Bull. 1335 Instruction Manual

Revision to Publication 1335-5.0

12 - 36 Amp Switching Modules

56 - 96 Amp Switching Modules

BULLETIN 1335 56 & 69 AMP DRIVES
POWER SWITCHING MODULE — P/N 120784

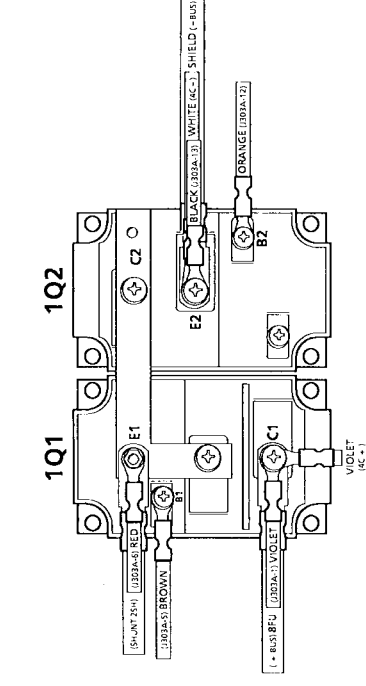
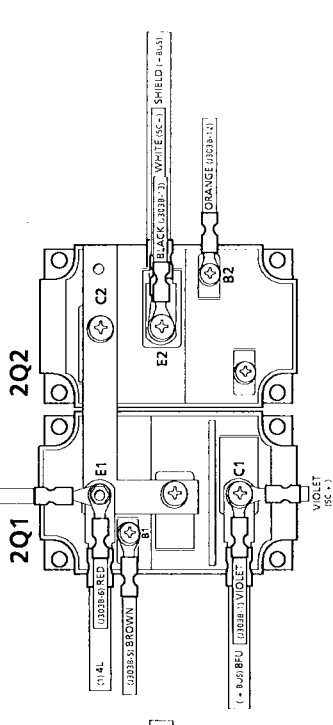
Power Switching Module **1Q1, 2Q1, 3Q1, 1Q2, 2Q2, and 3Q2**
P/N 201411

has been changed to:

CAUTION: Bulletin 1335 56 through 96 Amp Drives use two Power Switching Modules connected in series in each phase of the three-phase output. To avoid damage to the Drive, modules connected in the same phase must use the same part number. This will require changing both modules in a phase even though only one module needs to be replaced. Old and new modules may be identified by their physical difference. See page 3 for connection details.

P/N 120784

NOTE: A Spare Parts Kit is available that will provide the necessary components to replace one phase of the Drive. The kit includes:

- (2) Power Switching Modules (P/N 120784)
- (1) Connection Bar (P/N 133384)
- (1) Thermal Grease Packet (P/N 201686)

BULLETIN 1335 77 & 96 AMP DRIVES
POWER SWITCHING MODULE — P/N 120784

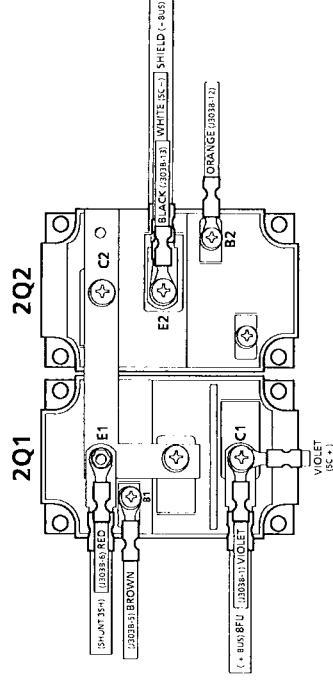
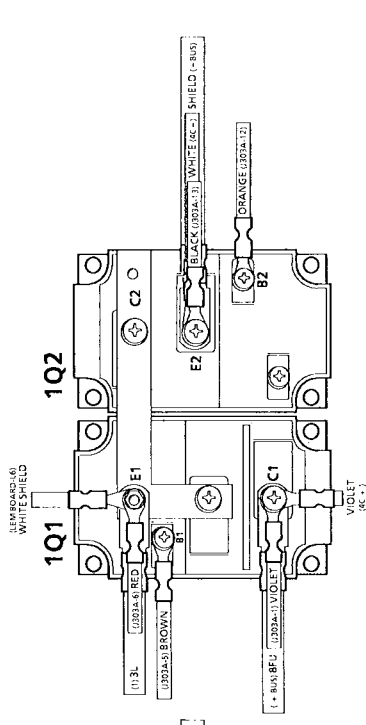
Power Switching Module **1Q1, 1Q2, 2Q1, 2Q2, 3Q1 and 3Q2**
P/N 201411

has been changed to:

CAUTION: To avoid damage to the Drive, Power Switching Modules connected in the same phase must use the same part number. This may require changing both modules in a phase even though only one module needs to be replaced.

P/N 120784
